Subject: Transmittal of Revision 2 Service Bulletin Number V2500-NAC-78-0183

Number: V2500-NAC-78-0183

SUBJECT: THRUST REVERSER OUTER V-BLADE - APPLICATION OF DRY FILM LUBRICANT

Thrust Reverser Outer V-Blade Modification
Figure 1 (Sheet 1)

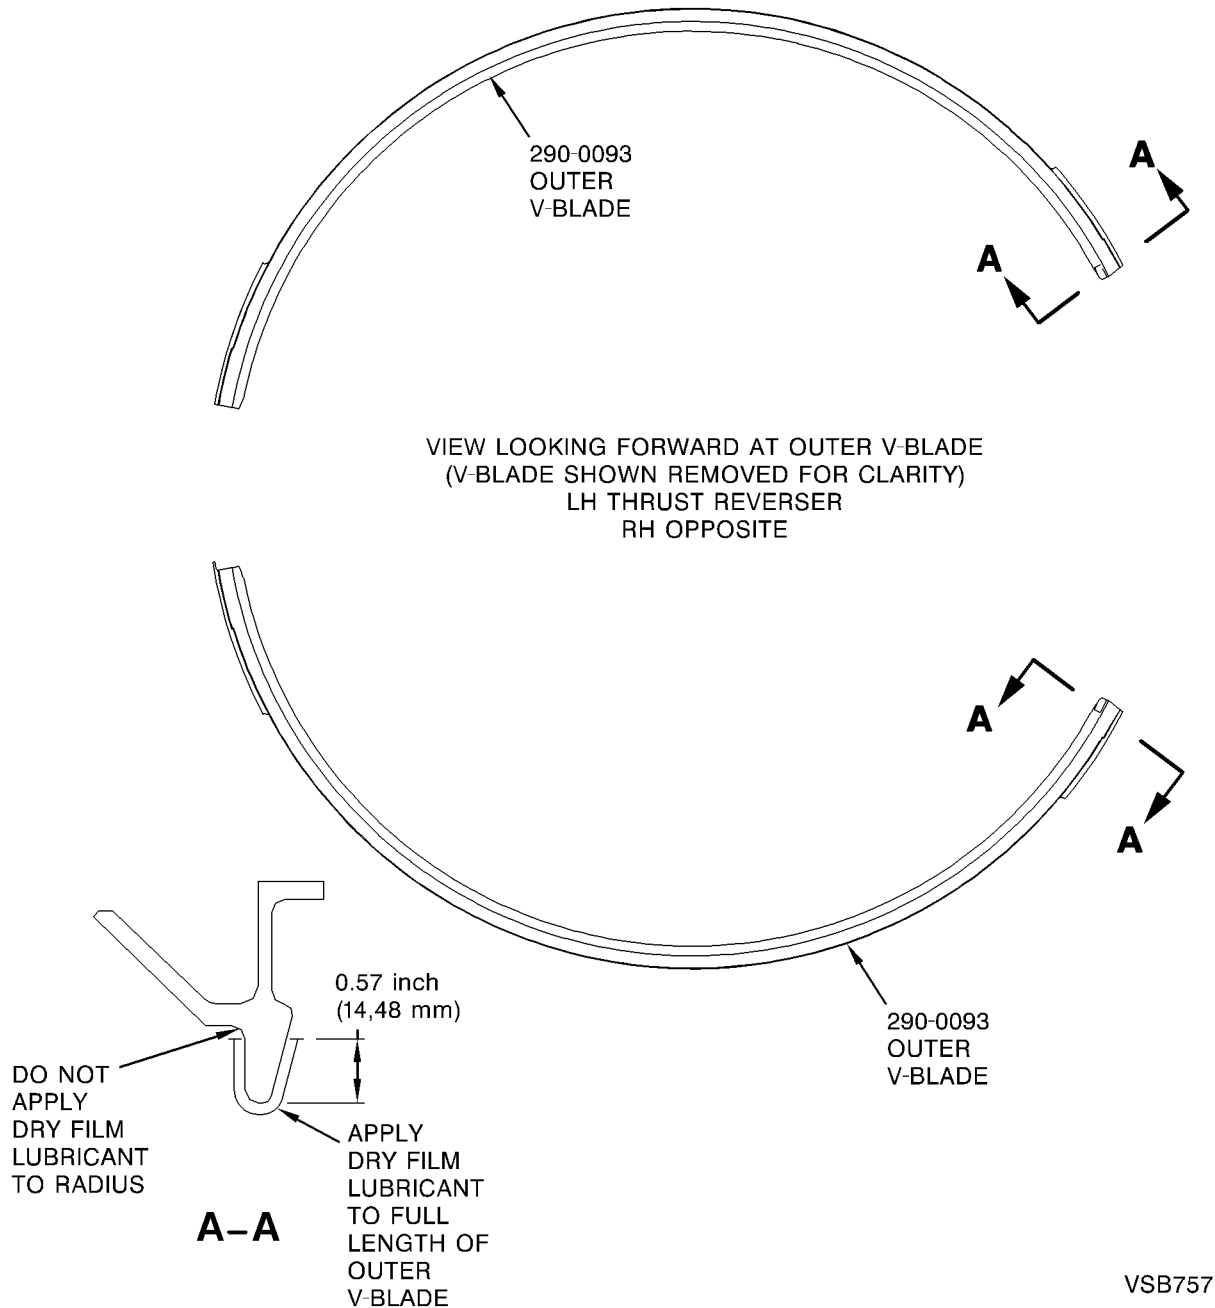
- (2) Apply dry film lubricant (CoMat 10-005) to the entire length of the v-blade. Do not apply dry film lubricant to the radius of the v-blade. Refer to Figure 1.

NOTE: It is important to avoid application of dry film lubricant to the radius of the v-blade. Dry film lubricant in the radius will interfere with inspection of the v-blade.

NOTE: To ease application of the lubricant to installed v-blades, use a paint roller. Modify the roller to get the required coverage and avoid application of the lubricant to the radius of the v-blade. Refer to Figure 1.

- a. Protect the areas to which you do not want to apply dry film lubricant.
- b. Apply four layers of dry film lubricant to the v-blade. Allow the lubricant to cure for a minimum of 10 minutes after you apply each layer.
- c. Cure the dry film lubricant.
 1. Allow the dry film lubricant to become dry-to-touch. Cure may be accelerated with a heat gun or heat lamp at 200 degrees F.
